Device	XMC1100
Marking/Step	EES-AB, ES-AB, AB
Package	PG-TSSOP-16/38, PG-VQFN-24/40

Overview

This “Errata Sheet” describes product deviations with respect to the user documentation listed below.

Figure 1 Clock Selection Diagram for CCU4/CCU8

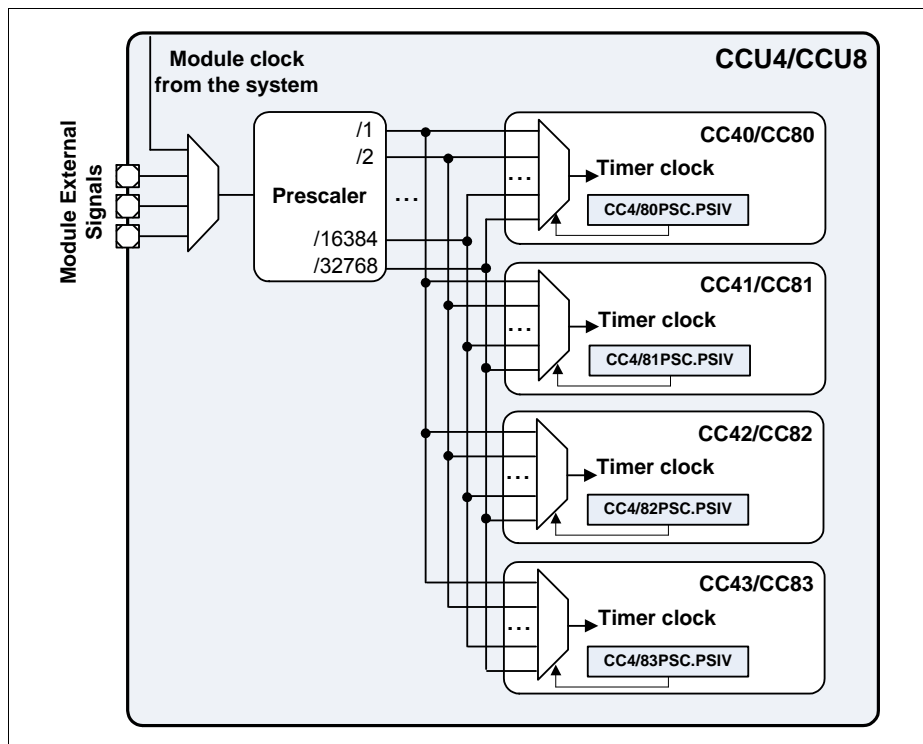
CCU AI.005 CCU4 and CCU8 External IP clock Usage

Each CCU4/CCU8 module offers the possibility of selecting an external signal to be used as the master clock for every timer inside the module Figure 1. External signal in this context is understood as a signal connected to other module/IP or connected to the device ports.

Currently is only possible to use an external signal as Timer Clock when a division ratio of 2 or higher is selected. When no division is selected (divided by 1), the external signal cannot be used.

The user must program the PSIV field of each Timer Slice with a value different from 0000_B - minimum division value is /2.

Workaround

None.
